UNITED STATES PATENT AND TRADEMARK OFFICE

APPLICATION NO.	FILING DATE	FIRST NAMED INVENTOR	ATTORNEY DOCKET NO.	CONFIRMATION NO.
09/822,606	04/02/2001	Paul Gaschke		8217

Office Action Summary

DETAILED ACTION

Fig. 1 below).

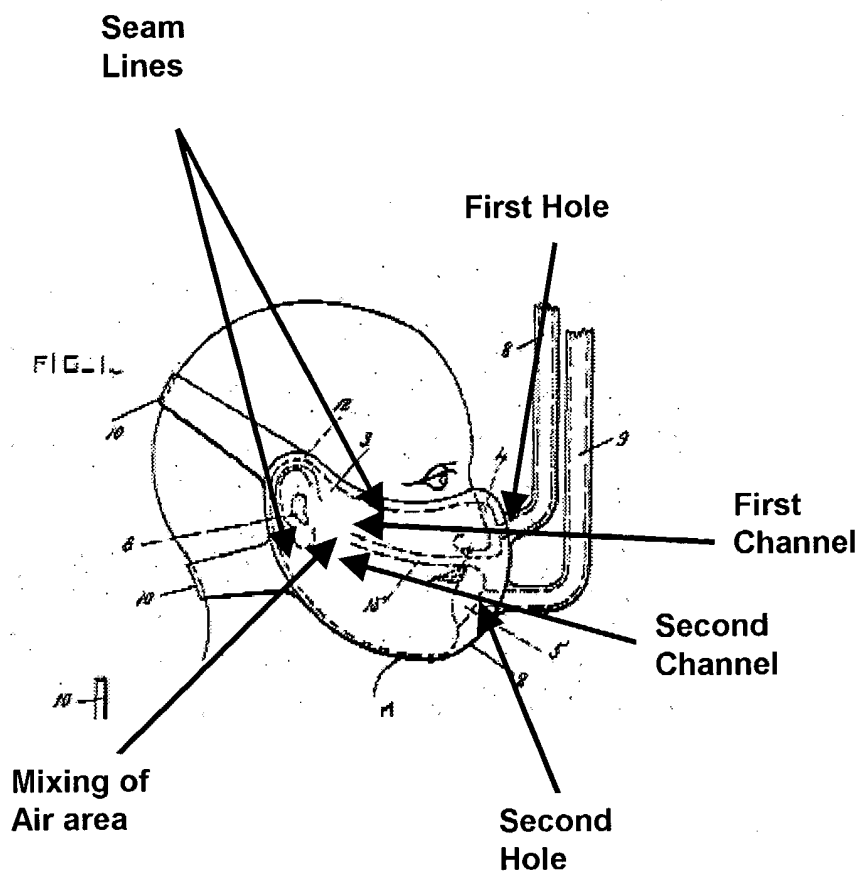
- a garment (2) adapted and configured to fit over a portion of a user's face;
- a first member (4) defining a first hole (see illustration of Fig. 1 below) in fluid communication with the nostrils of the user and a first channel (see illustration of Fig. 1 below) adapted and configured for accepting air flowing from the first hole, the first channel diverting the air laterally from the nostrils (see illustration of Fig. 1 below; inasmuch as air flows from the nostrils of the user and hits element 15, this thereby causing a lateral diverting of air from the nostrils), said first member being attached to said garment (2, note seam lines illustrated in Fig. 1 below); and

- a second member (5) defining a second hole (see illustration of Fig. 1 below) in fluid communication with the mouth of the user and a second channel (see illustration of Fig. 1 below) adapted and configured for accepting air flowing from the second, said second member being attached to said garment (2, note seam lines in Fig. 1 below);

- wherein a portion of the first channel is received within the second channel, and the air from the nostrils mixes with the air from the mouth in the second channel (see illustration of Fig. 1 below; inasmuch as air flows from the nostrils and mouth when the user breaths, this creates a flow of air from the

nostrils and mouth which would meet in the area depicted below illustrated in

With respect to claim 28, Conkle discloses wherein the second channel is adapted and configured to divert the air laterally from the mouth (inasmuch as air leaves the mouth of the user and hits element 15 this creates a diverting of air laterally from the mouth) and said second member (5) defines at least one exhaust port (via 9) for exhausting the nostril air and mouth air to ambient.

With respect to claim 30, Conkle discloses wherein said first member (4) includes a barrier (15) adapted and configured to direct air exhausted from one nostril to flow within the first channel (see illustration of Fig. 1 above) in front of the other nostril (inasmuch as when the user breaths out air via a nostril the air hits element 15 and therefore would divert flow within the first channel in front of the other nostril, by the movement of the air out of one nostril hitting element 15 some of the air would flow in front of the other nostril).

With respect to claim 31, Conkle discloses a garment (2) adapted and configured to fit over a portion of a user's face (Fig. 1); a first member defining a first hole (see illustration of Fig. 1 above) in fluid communication with the nostrils of the user and a first channel (see illustration of Fig. 1 above) adapted and configured for accepting air flowing from the first hole, the first channel diverting the air laterally from the nostrils (see illustration of Fig. 1 above), said first member including a barrier (15) adapted and configured to direct air exhausted from one nostril to flow within the first channel (see illustration of Fig. 1 above) in front of the other nostril (inasmuch as when the user breaths out air via a nostril the air hits element 15 and therefore would divert flow within the first channel in front of the other nostril, by the movement of the air out of one nostril

hitting element 15 some of the air would flow in front of the other nostril), said first member being attached to said garment (see seam lines depicted above with respect to illustration of Fig. 1); and a second member (see illustration of Fig. 1 above) defining a second hole (see illustration of Fig. 1 above) in fluid communication with the mouth of the user and a second channel (see illustration of Fig. 1 above) adapted and configured for accepting air flowing from the second hole, said second member being attached to said garment (see seam lines depicted above with respect to Fig. 1).
